SUBJECT: COMANCHE PEAK STEAM ELECTRIC STATION (CPSES)
DOCKET NOS. 50-445 AND 50-446
RESPONSE TO NRC INSPECTION REPORT
50-445/87-19, 50-446/87-15

Attached, please find TU Electric's responses to the HVAC Systems open items M-1 through M-14.

NRC Open Item No. H-1: TO ELECTRIC COMANCHE PEAK SES ~~1000~~ ...

Figure 1: Performance of a typical airconditioning unit with air-cooling coil and air-cooled condenser, From ASHRAE Handbook, Equipment Volume, 1983, page 19.3.

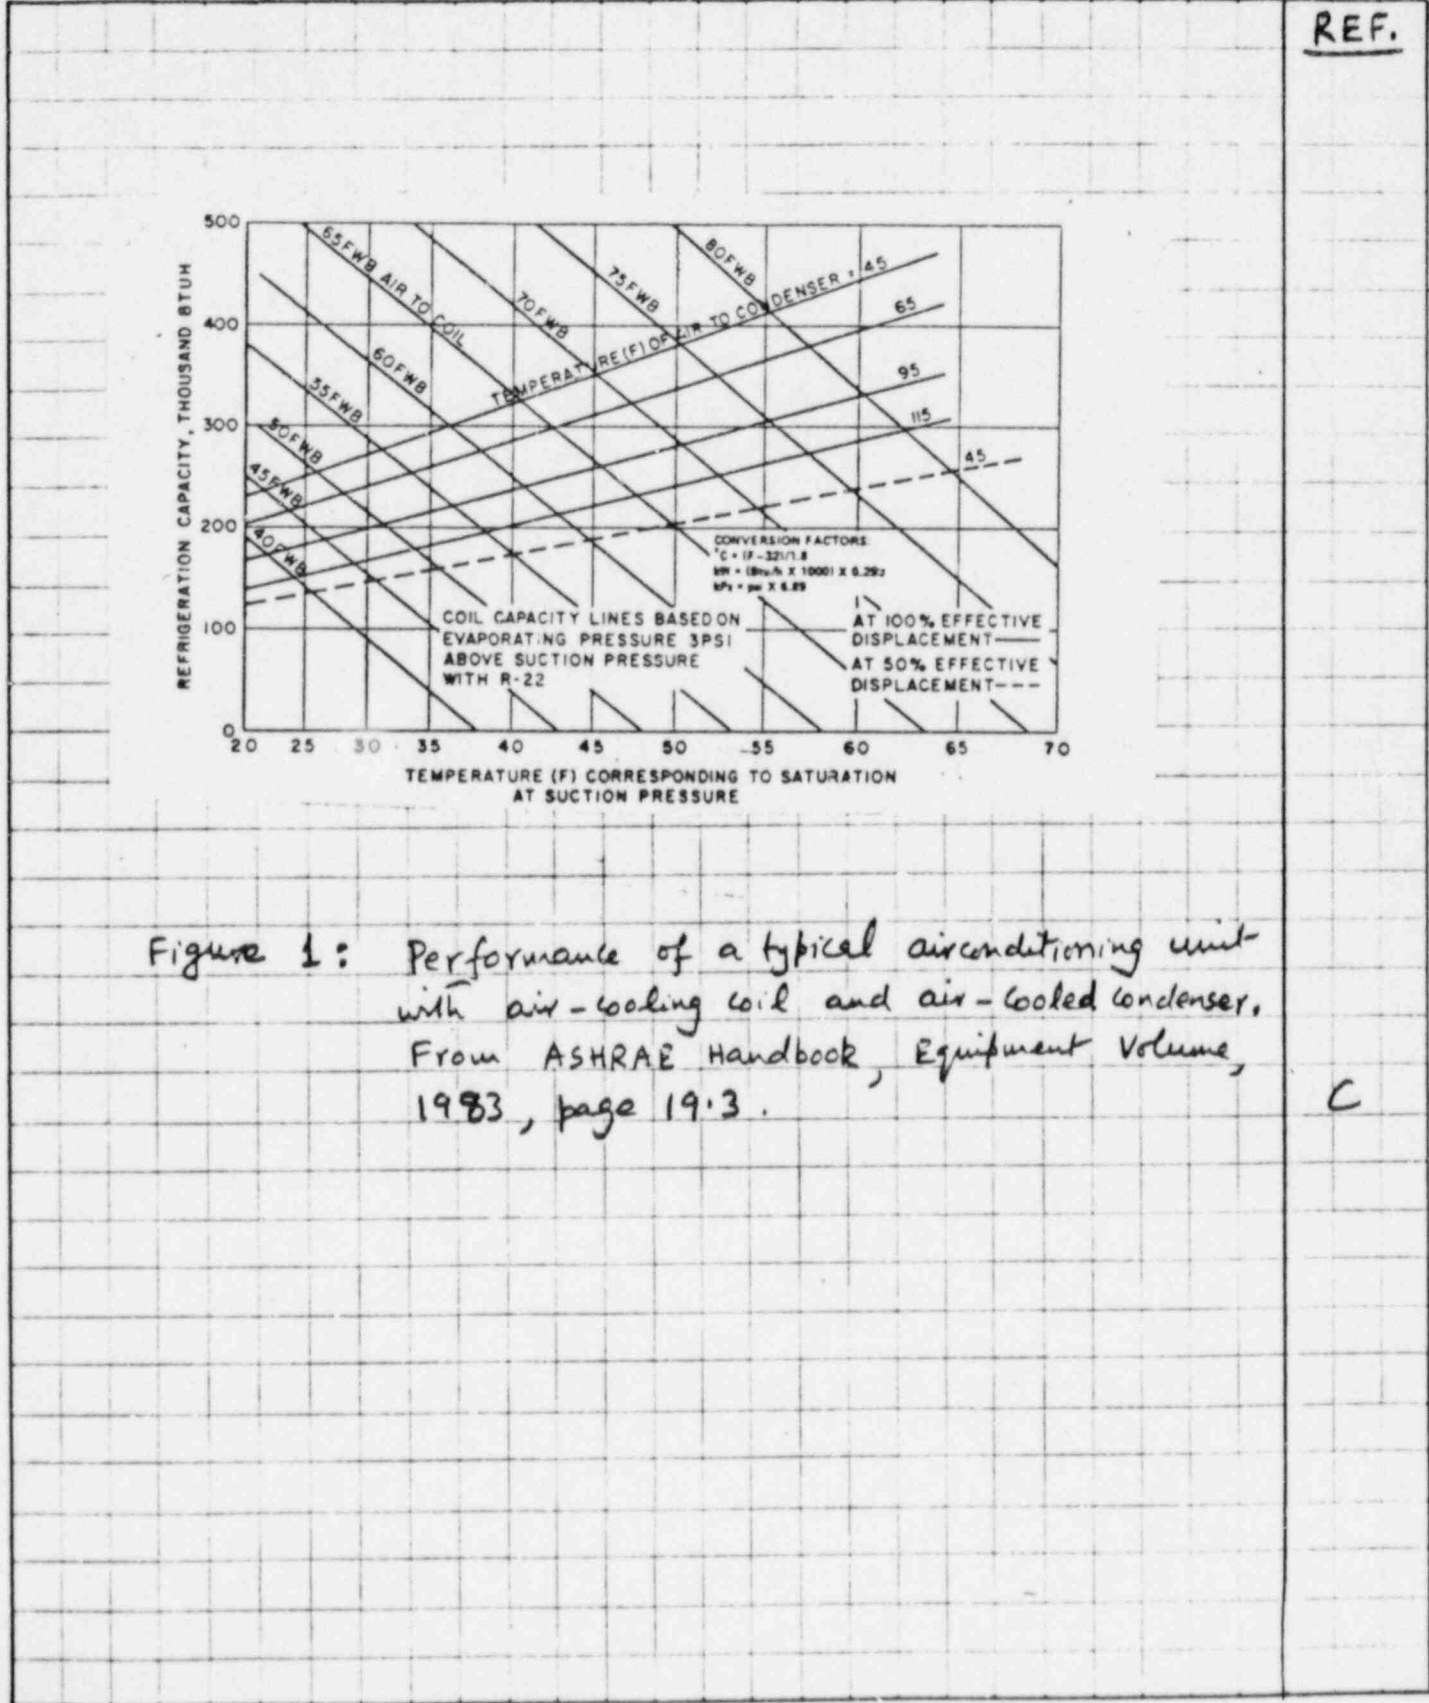
Figure 1 shows the effects of various parameters on the performance of a typical airconditioning unit. This figure refers to an air cooled condenser. Obviously, results will qualitatively be the same if a water-cooled condenser with constant water flow rate is used.

From Figure 1, the following conclusions may be drawn:

That the trends shown in Figure 1 are typical may be confirmed by studying ASHRAE Handbook (Reference C) as well as catalogs of various manufacturers. Attachments 1 and 2 are typical catalog data.

Figure 2
Emergency Recirculation Mode

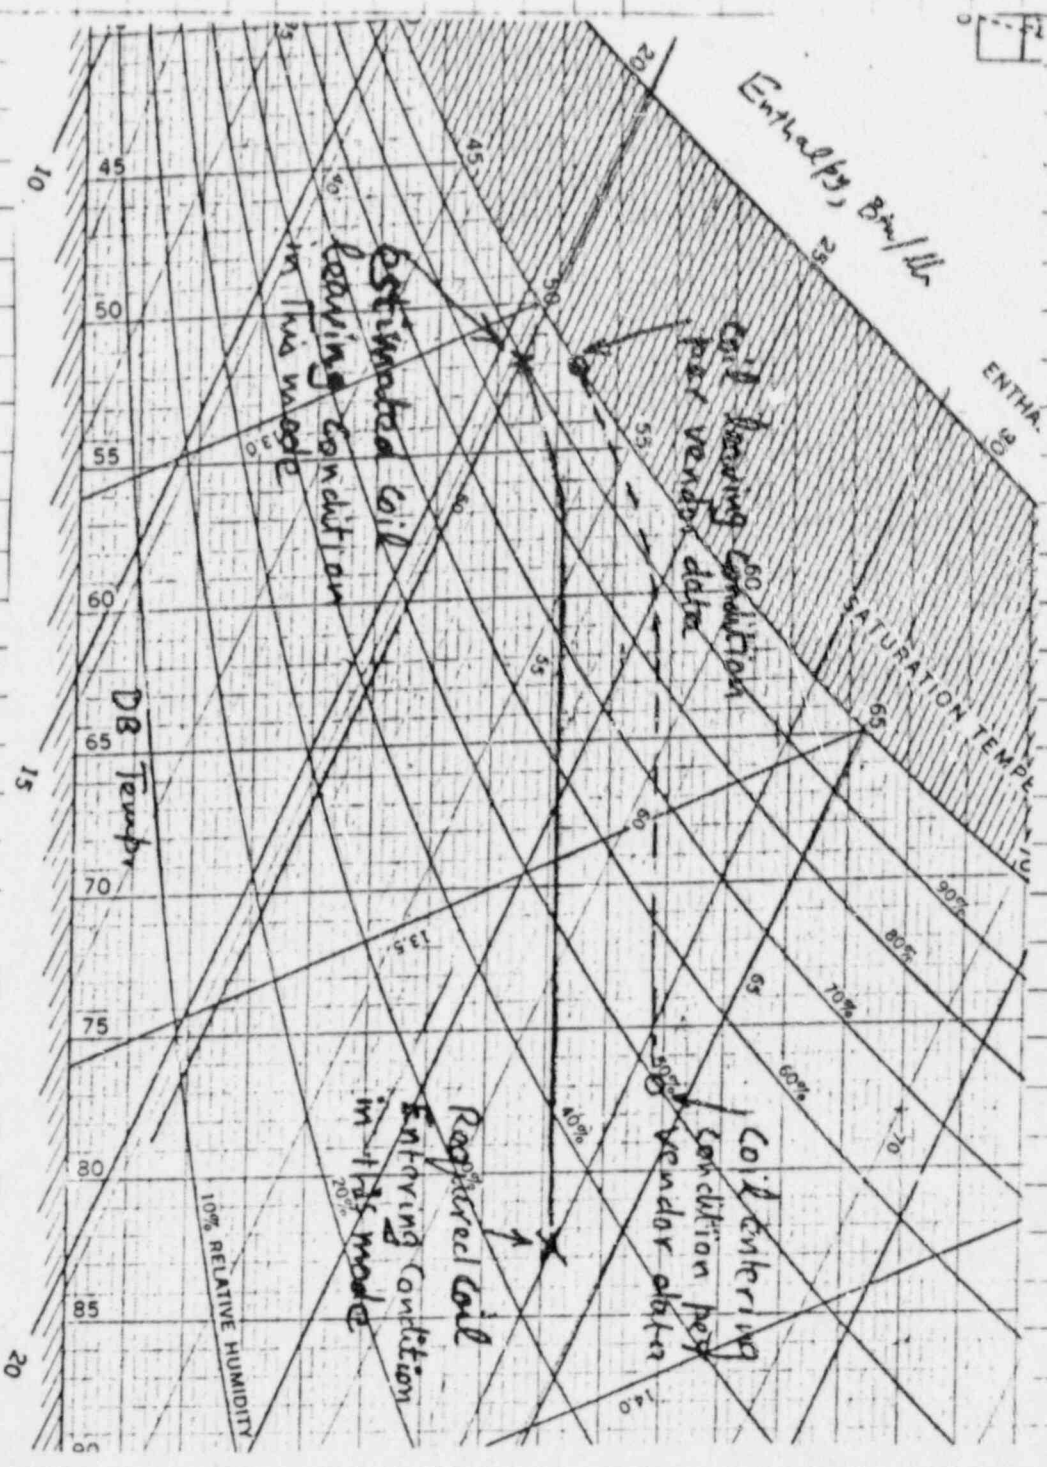
Hence the coil outlet condition should be on the 20.57 Btu/lb enthalpy line. Typical variation of air conditions during passage through cooling coil is shown on the TRANE Co. psychrometric chart (Attachment 4). In Figure 2 the coil inlet and outlet conditions given by the AC vendor are joined by a curve on this basis. Then a curve is drawn through the present coil inlet condition, taking guidance from the curves in the Trane psychrometric chart and the vendor

Thus it has been shown that both the sensible and latent cooling capacities of air conditioners under the condition of LOCA with emergency recirculation exceed the requirements.

Calculation X-EB-304-4 will be revised as shown in the attachment. In this revision, it is demonstrated by explicit calculations that the sensible cooling capacity requirements are met by the air conditioners under all operating modes. This calculation will be completed by November 7, 1987.

Figure 3

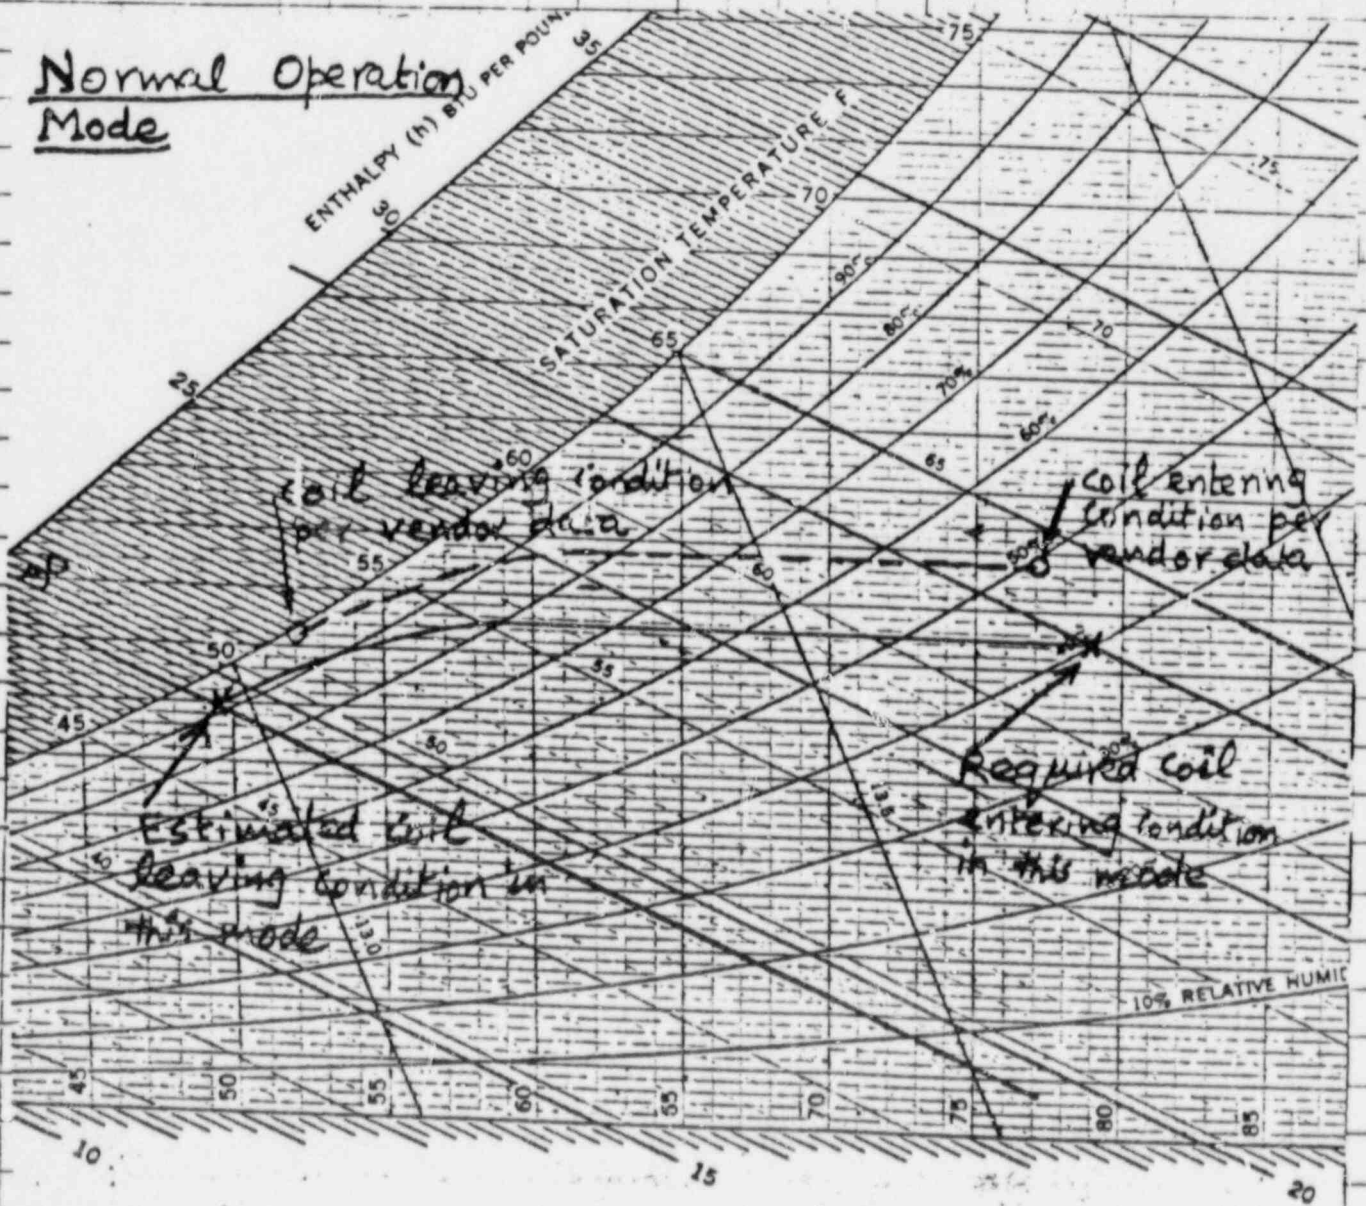
Normal Operation Mode
